BIORID II C4 NECK ACCELEROMETER MOUNT

Service Bulletin

January 2020

Recommendations for the C4 accelerometer location on the neck vertebrae of the BioRID dummy have been approved by the BioRID TEG with respect to GTR 7.

Figure 1- BioRID C4 accelerometer mount location

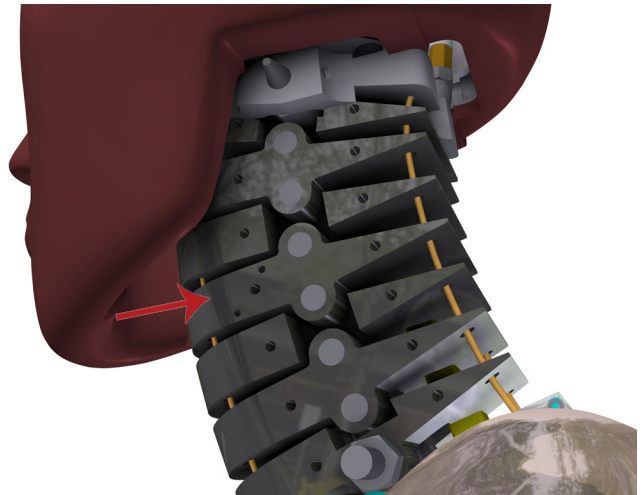
The original design of the BioRID dummy allowed for accelerometer mounting at certain points along the neck and spinal column. One of these locations was on the fourth cervical vertebrae (C4) of the neck (figures 1 & 2).

! Remove the accelerometer block located at the C4 location. If not removed, the head might contact the block and produce inaccurate upper neck measurement results.

OMIT C4 ACCELEROMETERS

Figure 2- BioRID C4 accelerometers

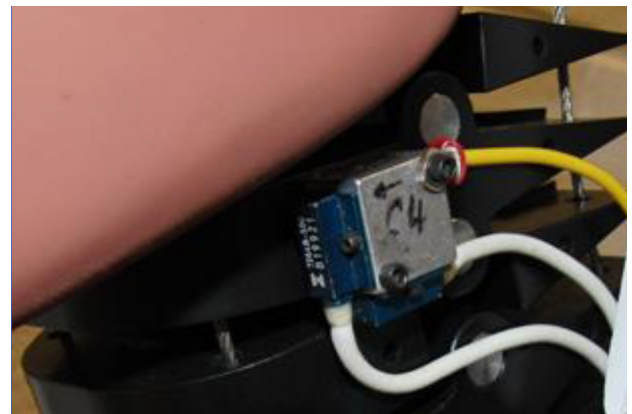
Chin to C4 accelerometer contact creates a load path around the upper neck load cell which makes all recorded upper neck loads invalid.

The GTR7 TEG has recently reviewed the issue and agreed with the recommendation to omit the C4 accelerometers and mount from the testing of the UN BioRID dummies.

Figure 3- BioRID C4 accelerometer impact marks on the chin

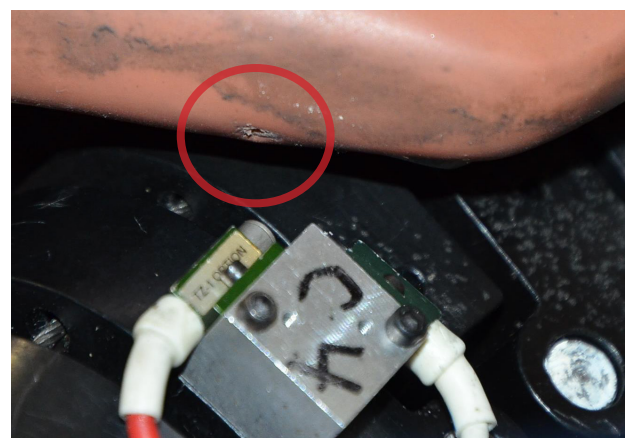
After investigation, it was found that sufficient flexion is possible for the chin to hit the C4 accelerometer or mount on either side of the neck. Witness marks on multiple customer dummies were observed showing contact that occurred during testing (figure 3) causing damage to the skin, skull, and accelerometer.
